SAFETY EVALUATION BY THE OFFICE OF NUCLEAR REACTOR REGULATION
RELATED TO AMENDMENT NO. 96 TO FACILITY OPERATING LICENSE NO. NPF-51

PALO VERDE NUCLEAR GENERATING STATION, UNIT NO. 2

DOCKET NO. STN 50-529

CONCEPTUAL
FUEL BUNDLE STRAP ASSEMBLY
STRAP SCHEME
QUESTION 1 FIGURE 1

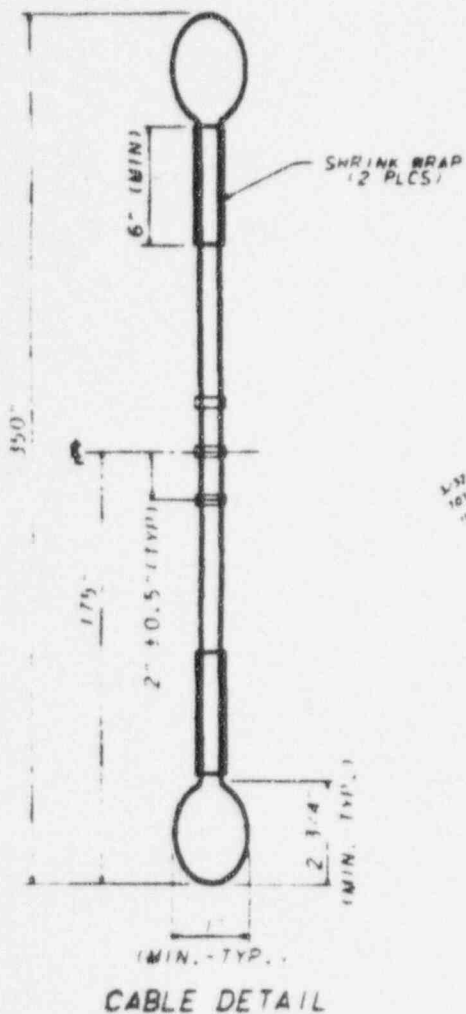
- (1) How will the structural integrity of the fuel assembly at location A-07 be assured during movement?

Structural integrity of the fuel assembly will be assured by installing external reinforcement using one of the following two methods:

The first method of reinforcement is the use of two separate 1-inch wide stainless steel straps installed on opposite sides of the assembly. The straps will be attached by clips to a steel jacking plate, installed on the upper plate at the top of the assembly, and to the web of the assembly's lower end fitting (LEF) (see Figure 1). The jacking plate will have adjusting bolts that will press against another steel plate underneath (the bearing plate) and thus pull up on, and tension, the straps. The straps will be tensioned enough to take up the slack, but not enough to compress the fuel assembly.

CONCEPTUAL
 TEMPORARY LIFT RIG
 REF: QUESTION #2
 FIGURE 3

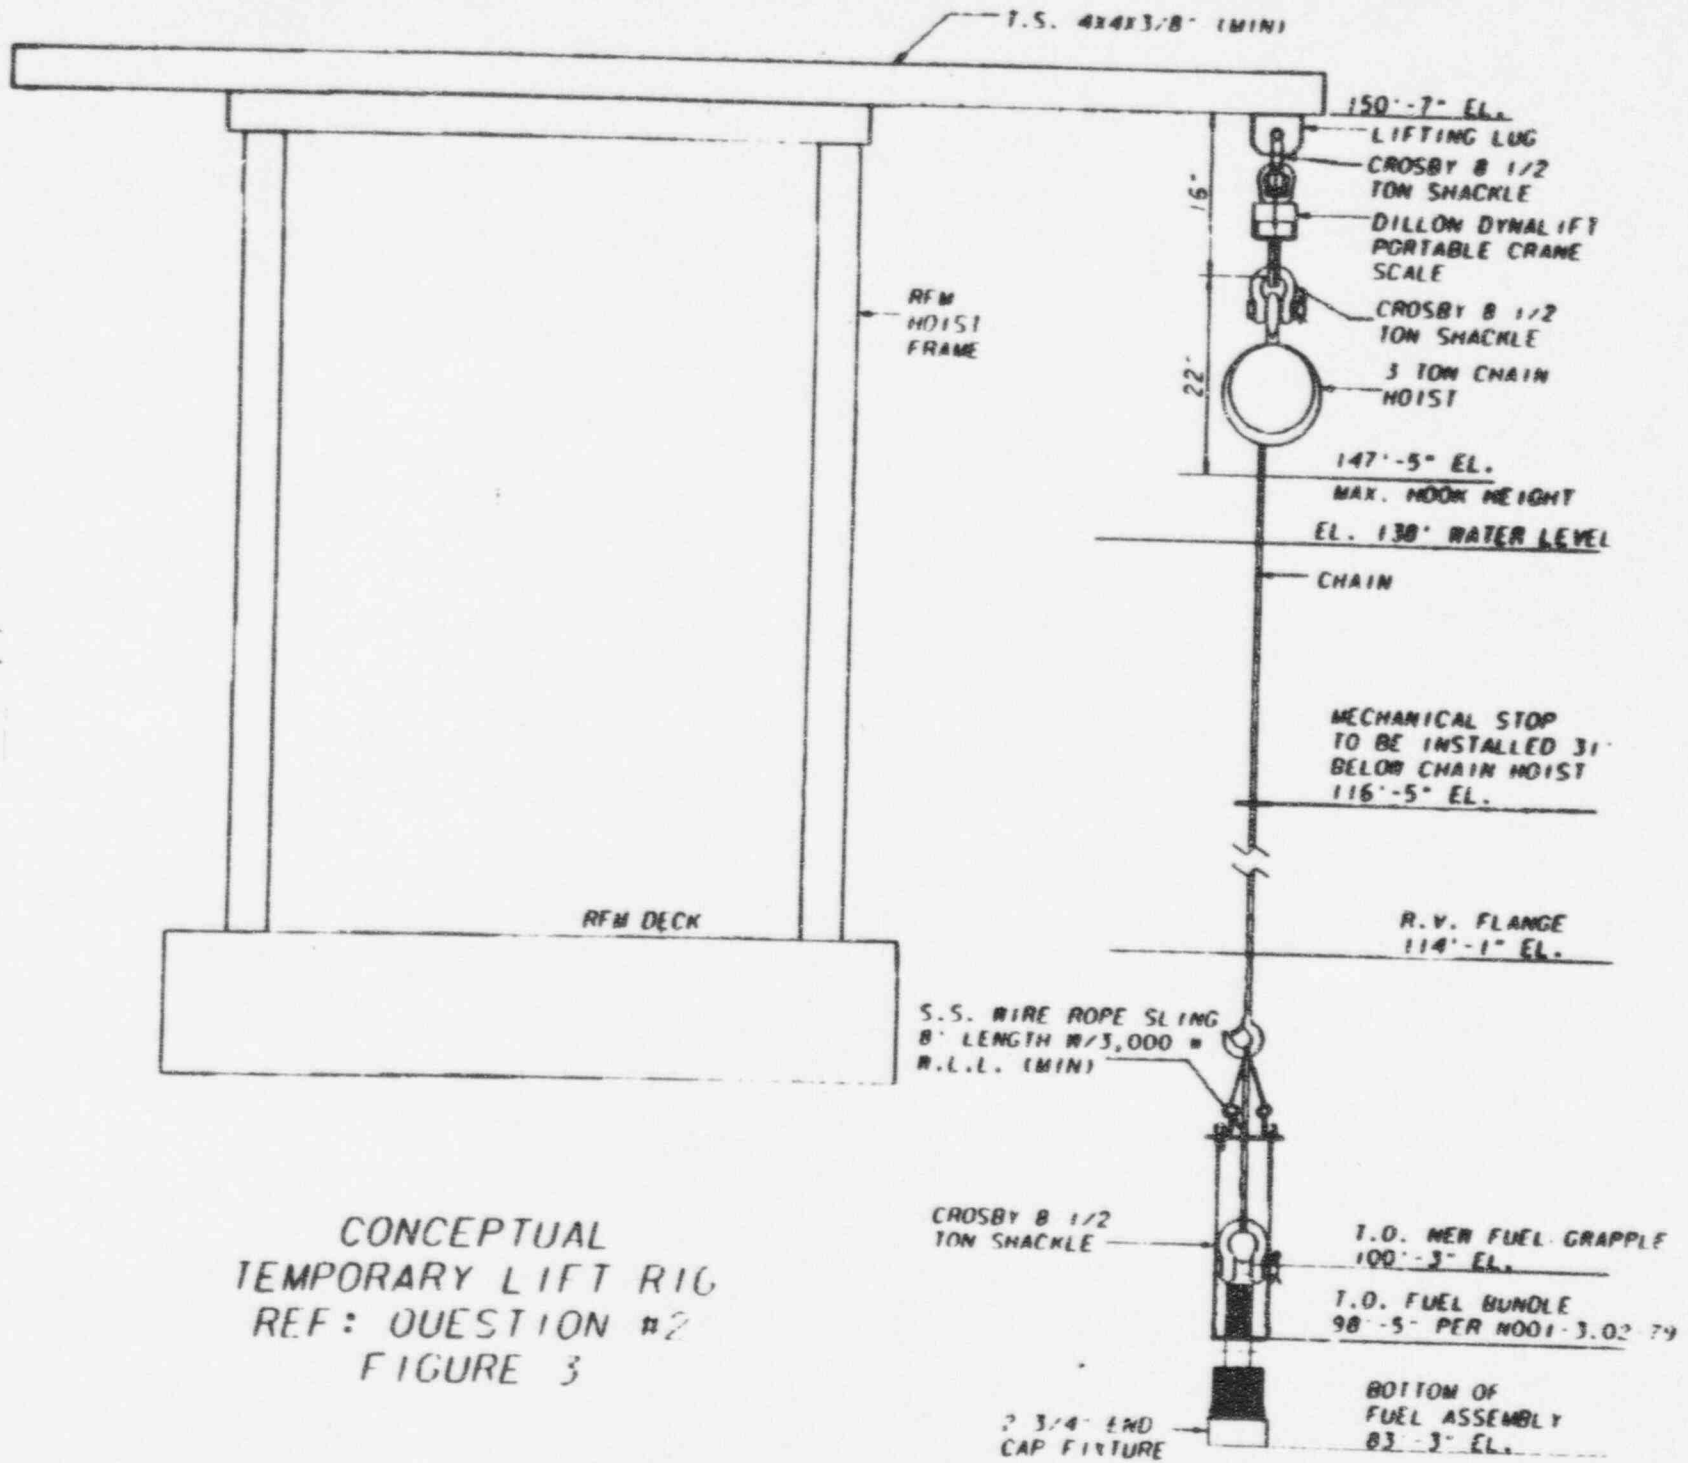
- (2) Describe how the temporary hoist will be attached to the refueling machine.

The temporary lift rig will consist of the following:

An 8-foot, 4-inch long, 4-inch square steel tube will run across the top of the refueling bridge hoist frame rails. The tube will be attached to the hoist frame rails by two 1/2-inch U-bolts and a 3/4-inch steel plate at each rail. The beam will extend 41 inches past one side of the refueling machine frame rail. A lug will be welded to the underside of the beam such that the load cell/hoist assembly will hang at a position 36 inches past the frame rail. The beam has a design capacity of at least 3000 pounds, which is approximately 1.5 times the maximum expected load.

A load cell (with a capacity of 5000 pounds) will be hung from the lug, welded to the underside of the beam at the end, extending past the refueling machine.

A hoist will be hung from the load cell.

The new-fuel grapple will be hung from the hoist.

A drawing is attached that shows the temporary lift rig attachment (see Figure 3).
